ADDENDUM NO. 5

Reference: New Classroom Building
UVU - Orem, Utah
DFCM Project No. 12192790

ADDENDUM NO. 5
May 22nd, 2013

Utah Valley University Classroom Building
Orem, Utah

B2 / SF107 Penthouse Roof Framing Plan

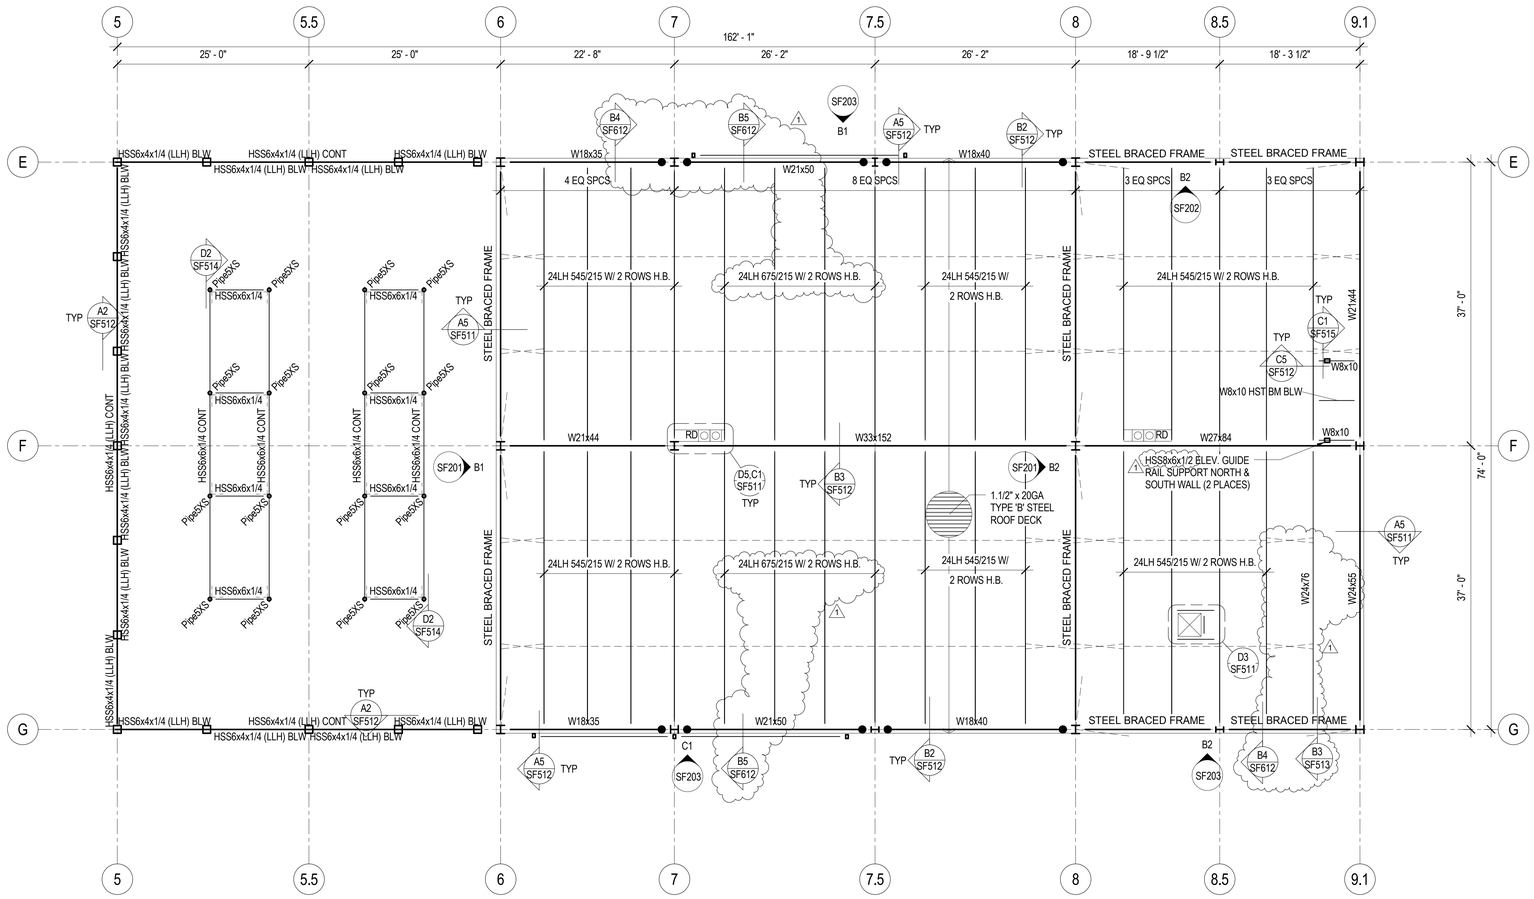
1. Add elevator guide rail support column size. See revised Sheet SF106B.
2. Revise framing member sizes between Grids 7-7.5 and between Grids F-G/8.5-9. See revised Sheet SF107.
3. Add detail cuts on Grid E and G. See revised Sheet SF 107.

B1 SF201 BRB - Along Grid '6'

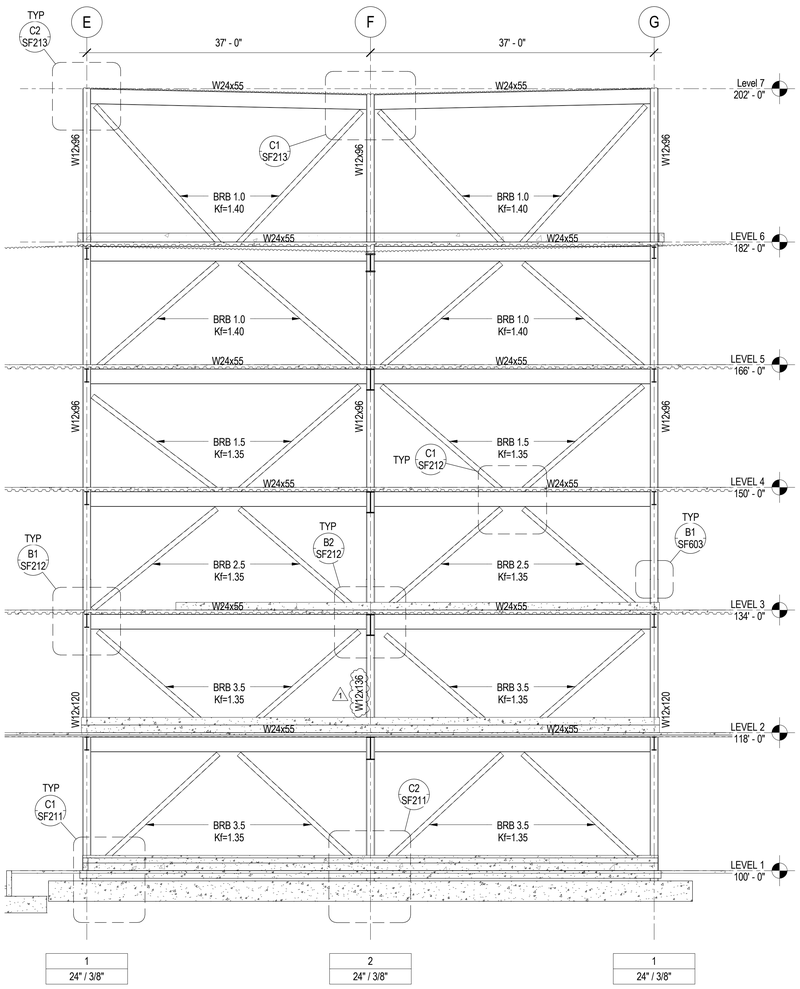
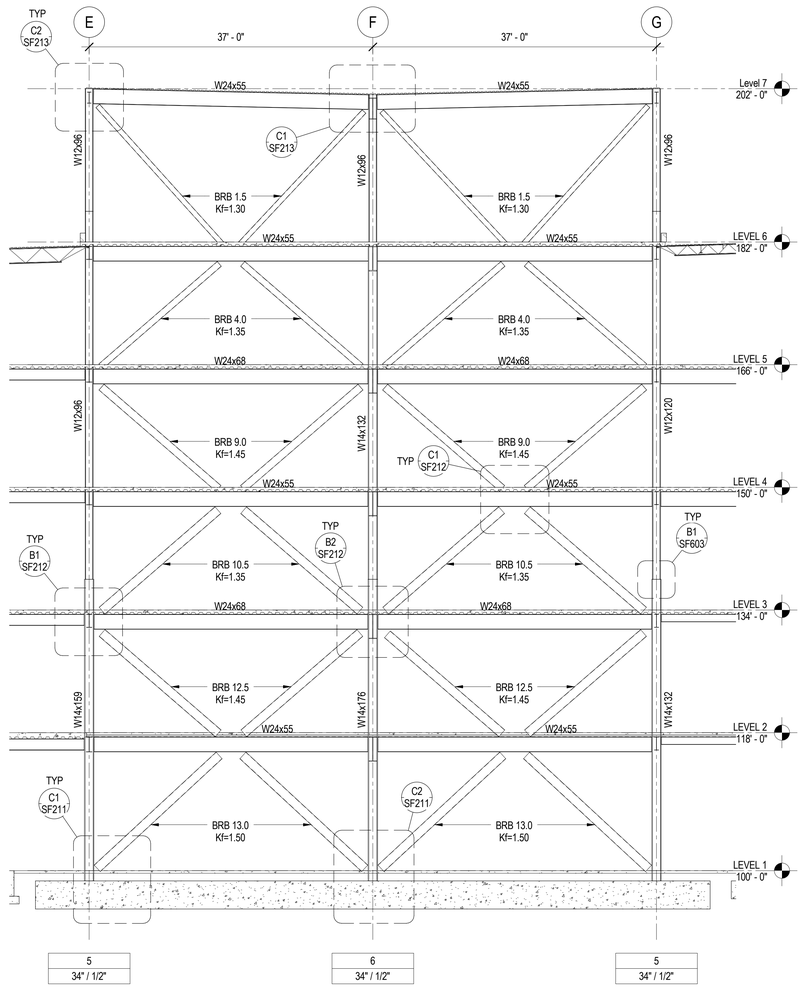
1. Change column size at Grid F/6. Level 1-3. See revised Sheet SF201.

Level 1 Area 'A' Floor Plan

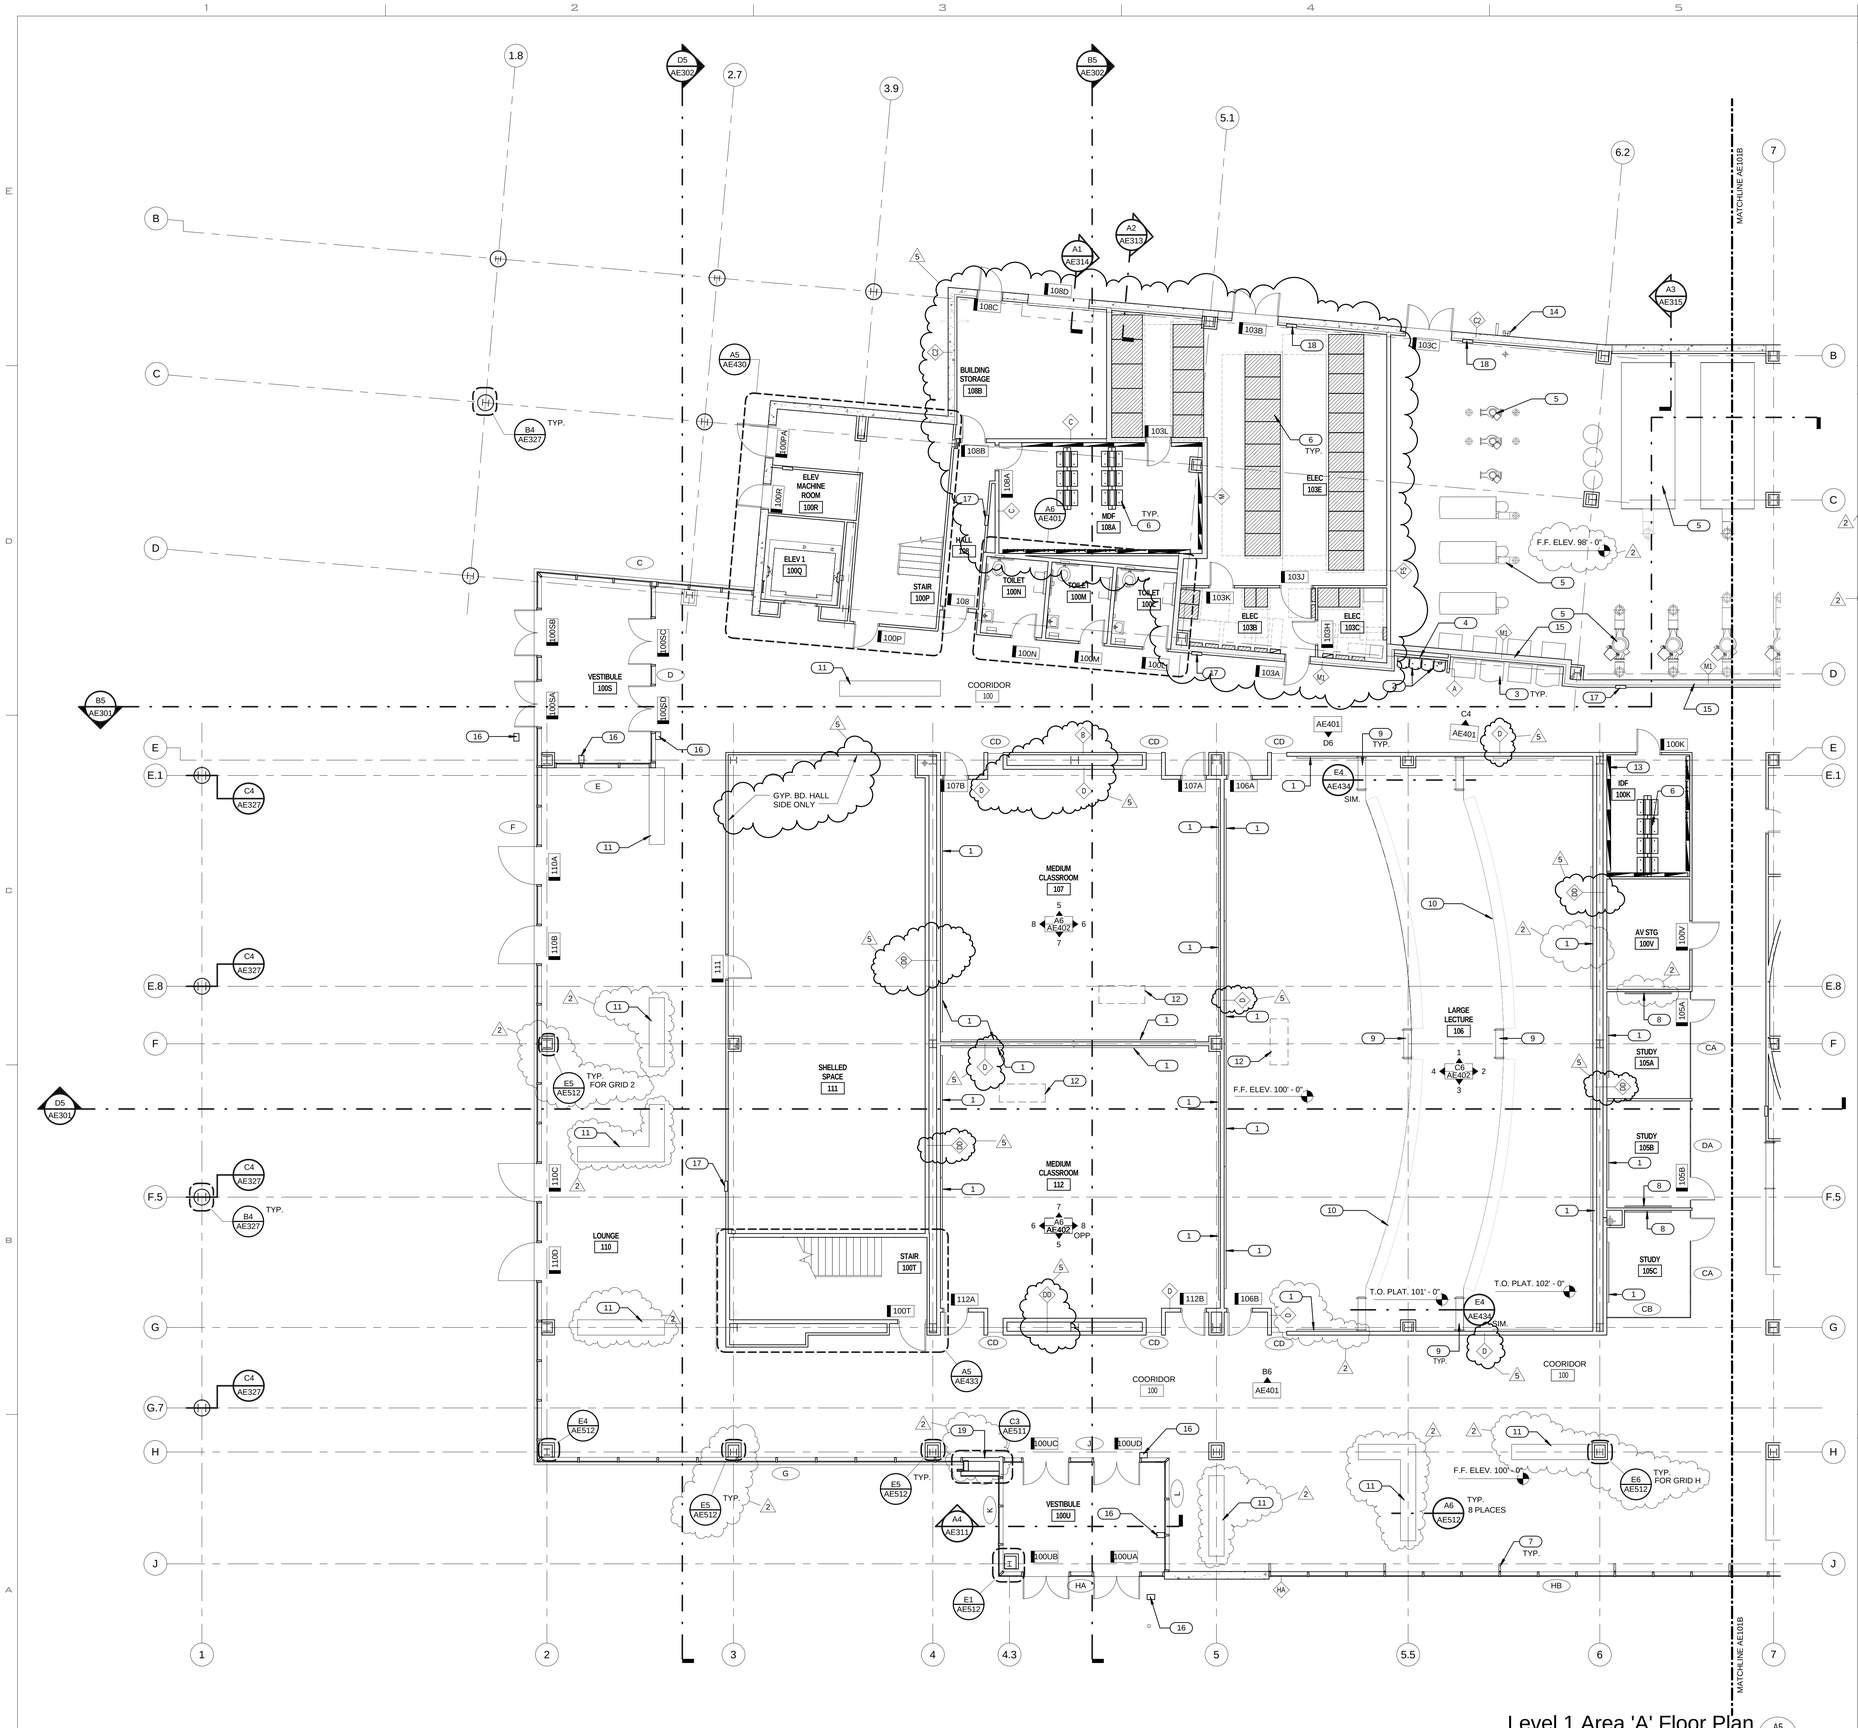
14. Sheets AE101A, AE101B, AE102A, AE102B, AE103A, AE103B, AE104A, AE104B, AE105B, AE403, AE412, AE501: Corrected wall types.
15. Sheet AE513: Corrected details A2, A5, A5.
16. Sheet AE107: Clarified roof types.
17. Sheet AE602: Added doors 103J, 103K, 103H, 103L.

Women Bathroom Room # 100D, 200D, 300C, 400C, 500C (D5 / AE404)
1/4" = 1'-0"

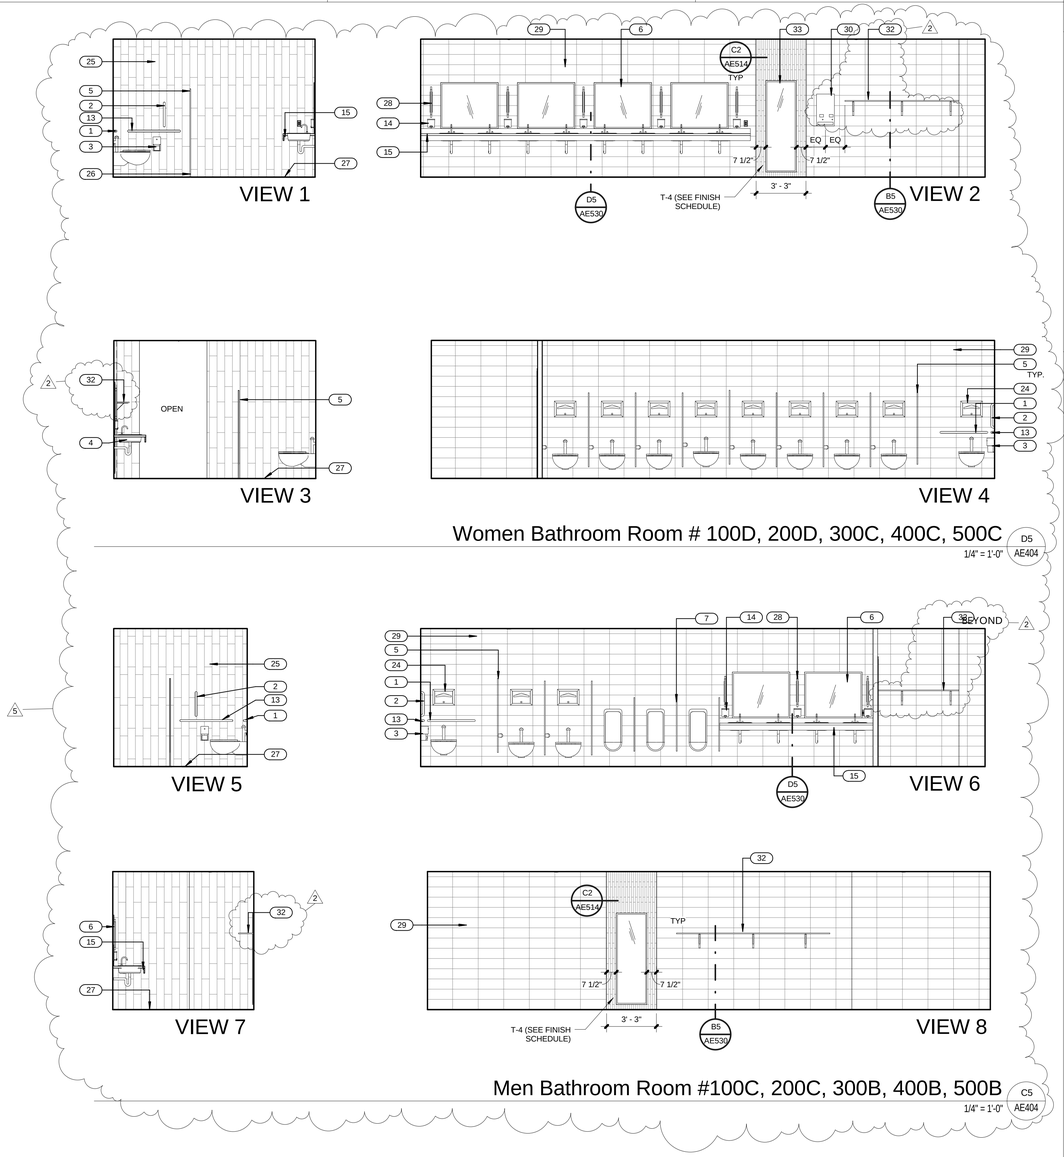
6. Section 102239 Revised to clarify finish on P-W3.
7. Sheet AE404, AE620
    1. AE404 detail C5-Added accent tiles and details, see attached sheet
    2. AE620-Added tile type T-4 and instructions, see attached sheet

1 LEVEL 1 AREA 'B' MECHANICAL FLOOR PLAN

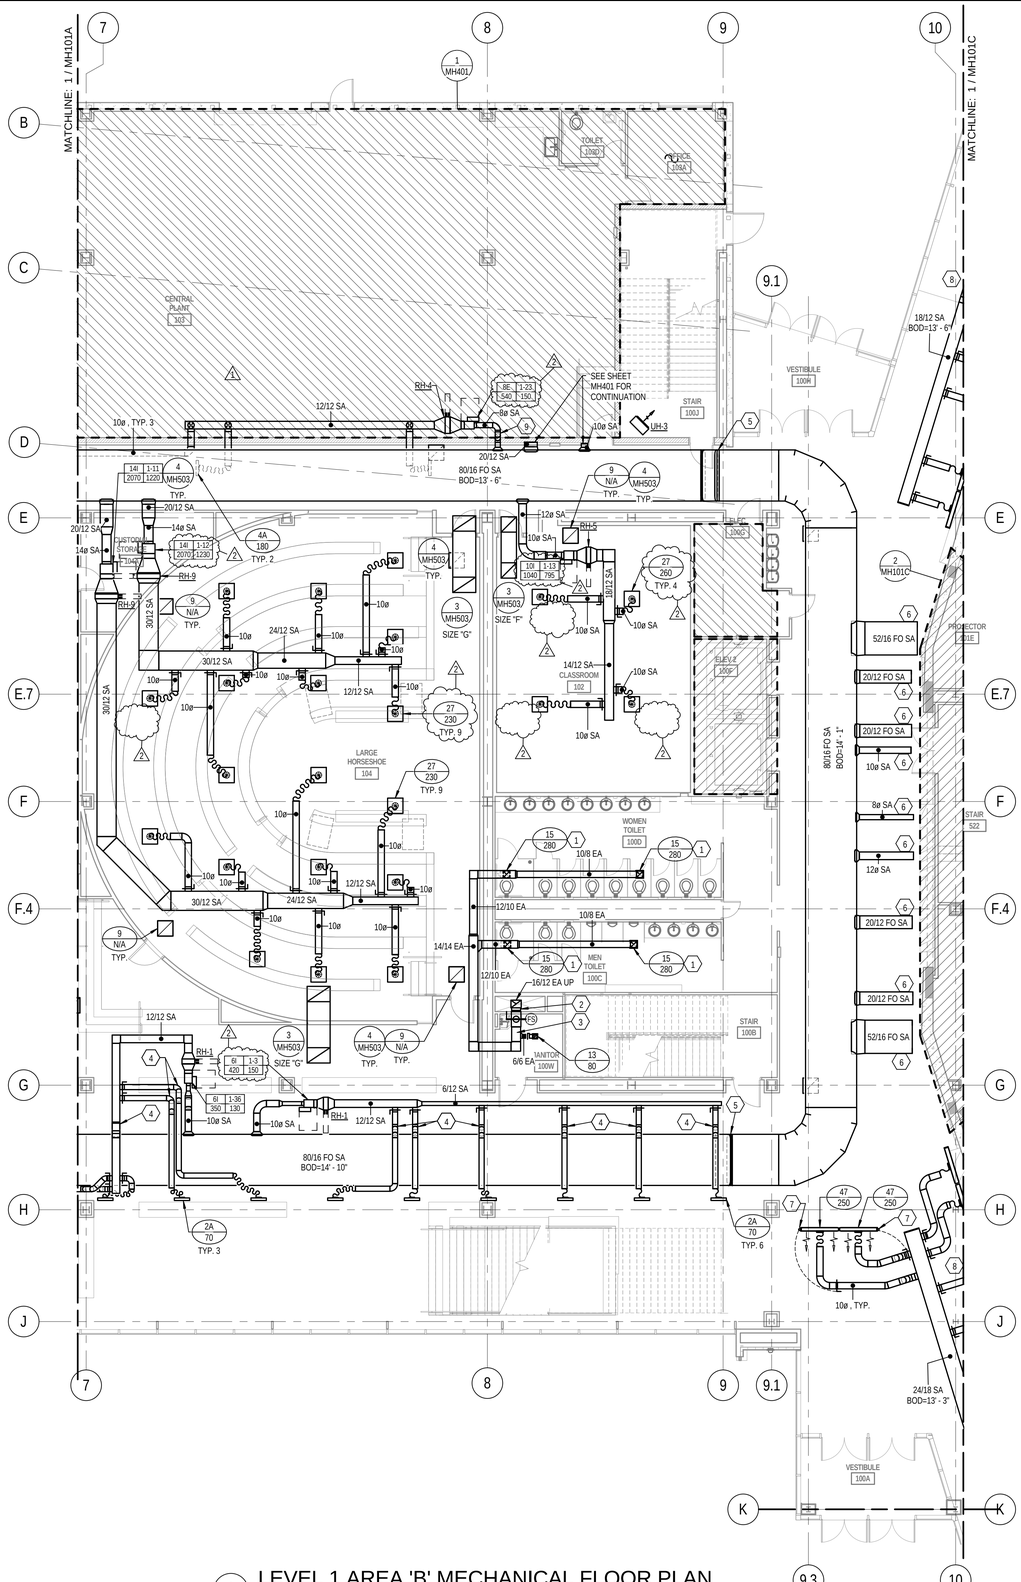
5.2	Clarify/Add	MH101A	-Clarify VAV box air flows. -Clarify keyed notes. -Added keyed note #20
5.3	Clarify	MH101B	-Clarify VAV box air flows.
5.4	Clarify	MH102.1 MP102.1	-Clarify VAV box air flows. -Delete VAV box 3-68. -Clarify VAV box numbers in various locations.
